**SECURITY FIRE STATION NO. 4**

**GRADING & EROSION CONTROL PLAN POND PLAN**

**C1.3** MVE PROJECT 61134  
 MVE DRAWING GEC-PP

PCD FILE # PPR-20-029  
 5777.50

**EXTENDED DETENTION SAND FILTER BASIN DETAIL**  
 SCALE: 1" = 10'

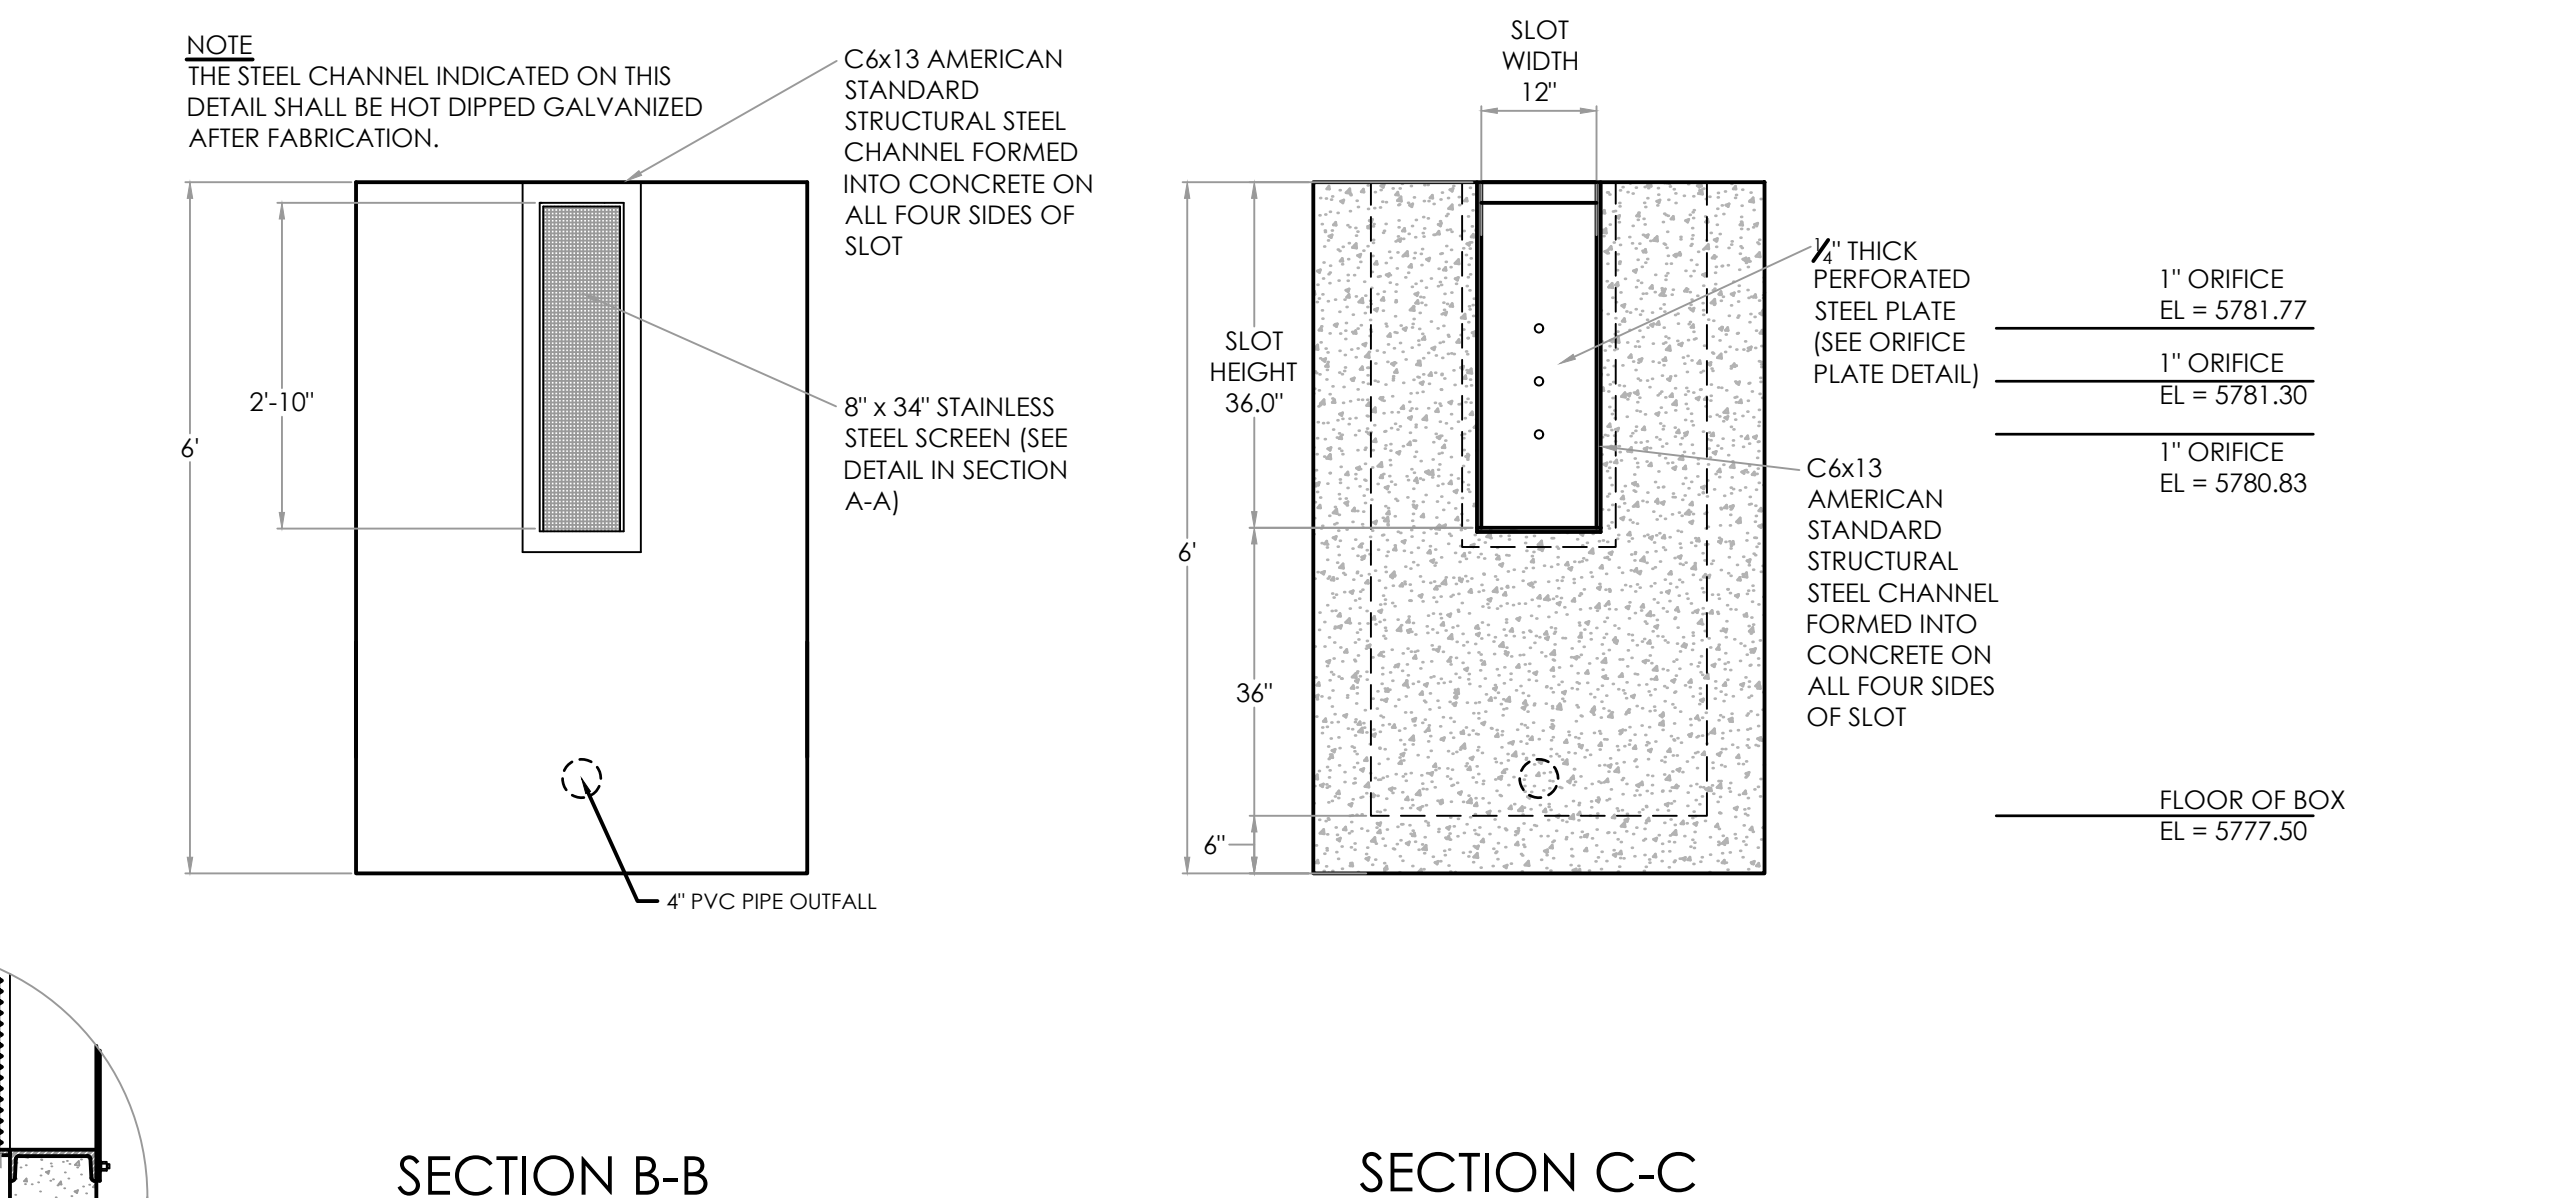
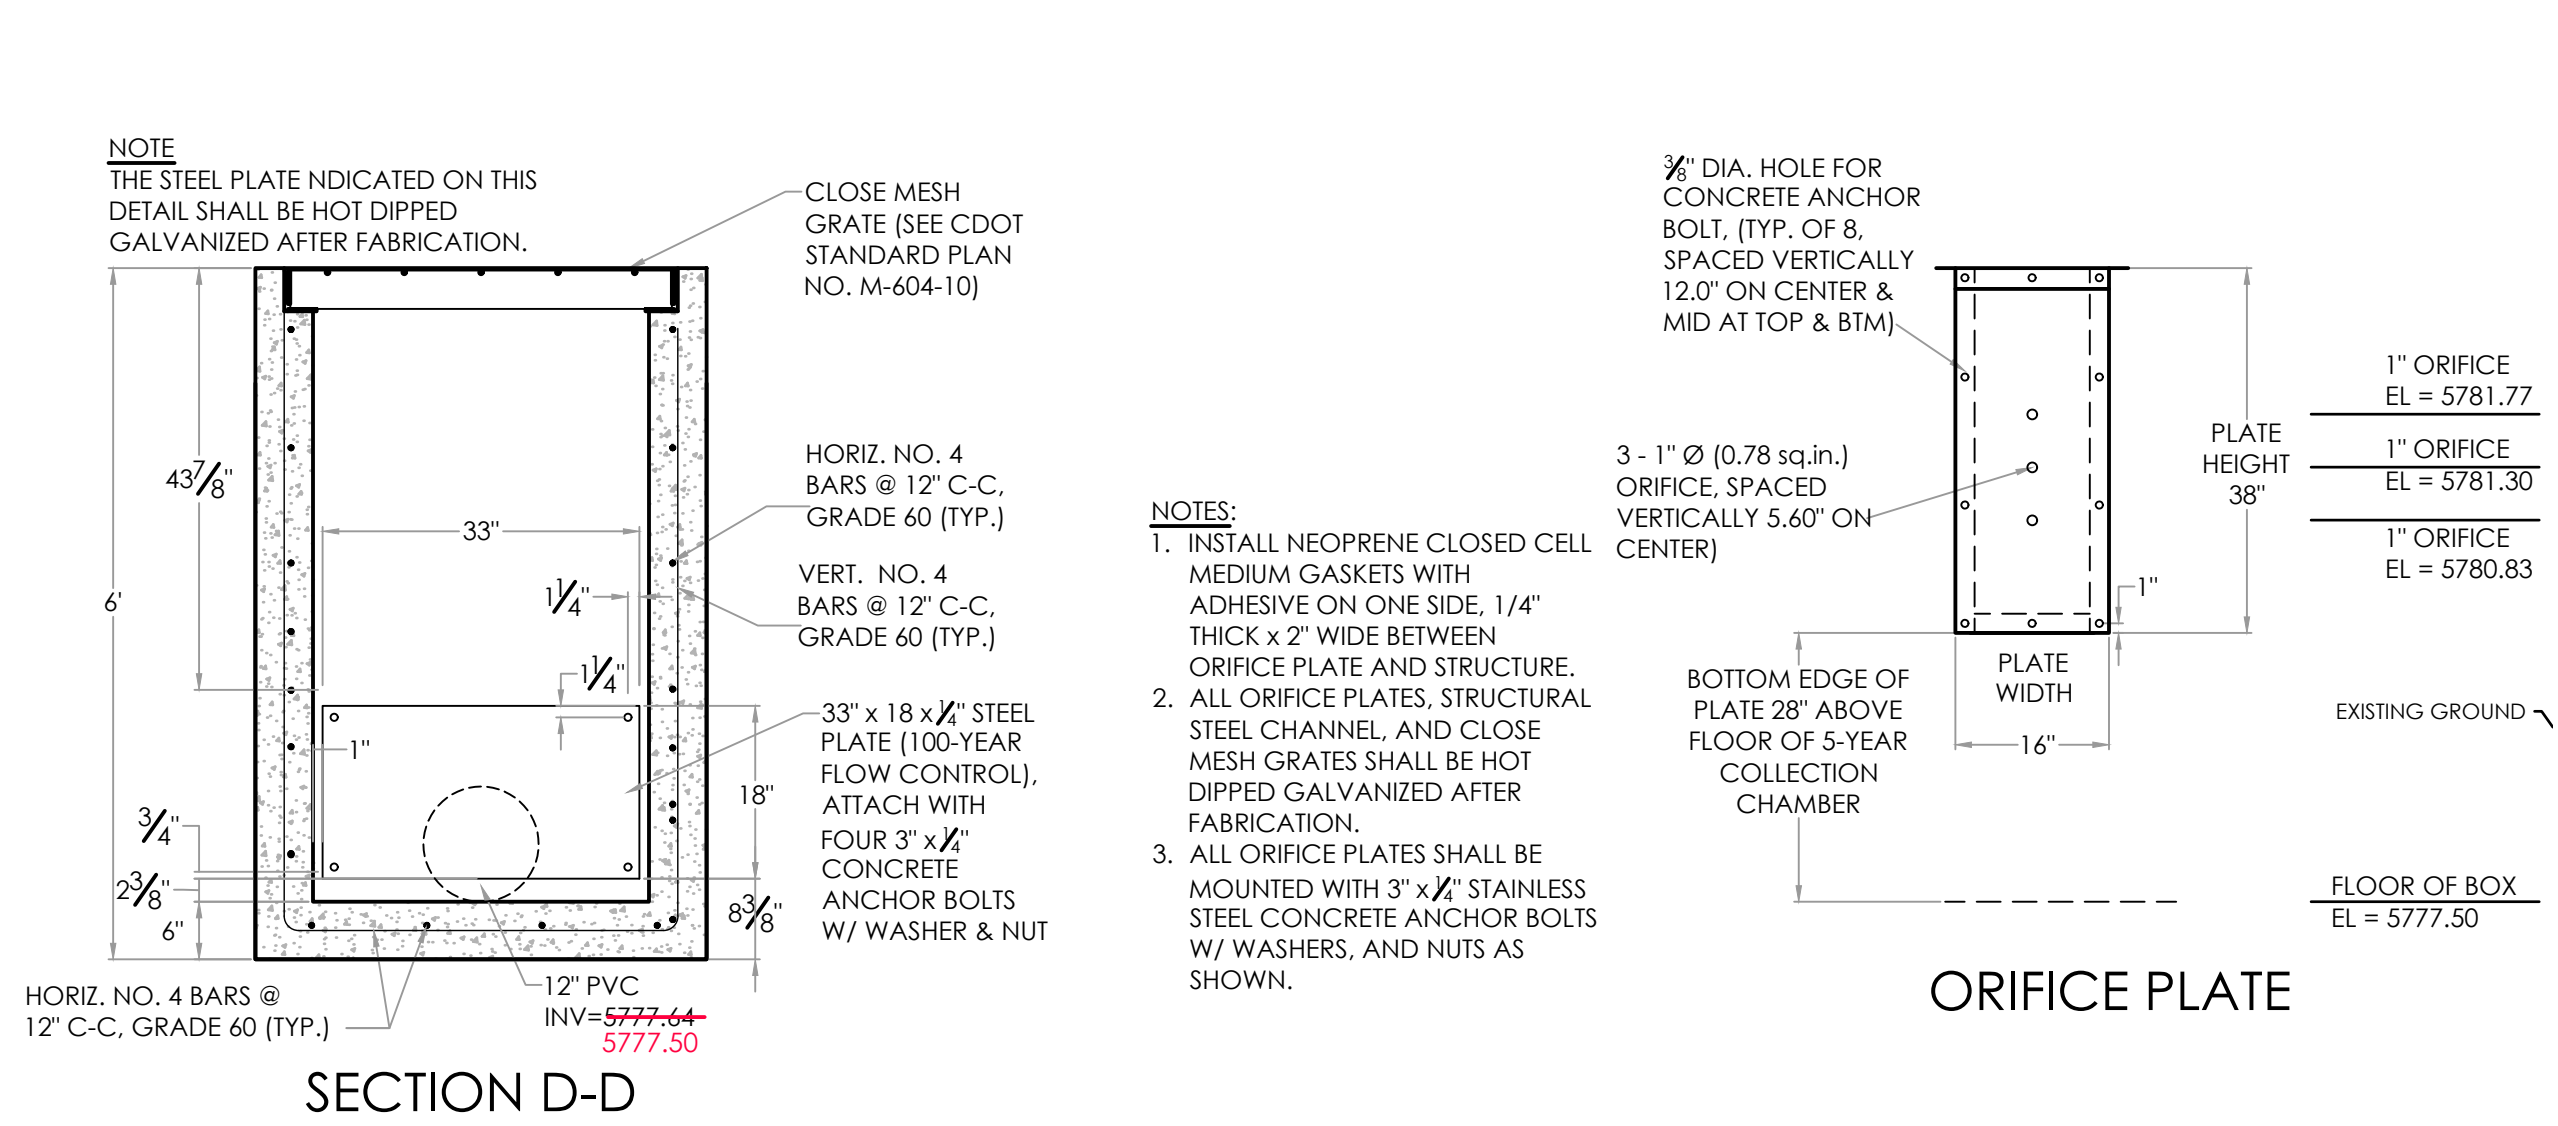
Even if everything was built exactly per plan, we need an electronic PDF of the original drawings to be signed, dated, and stamped with "As-Built" on each sheet.

The Detention Maintenance Agreement was never finalized or signed. Please work with the applicant/owner and the County Attorney (Lori Seago) to do so as soon as possible.
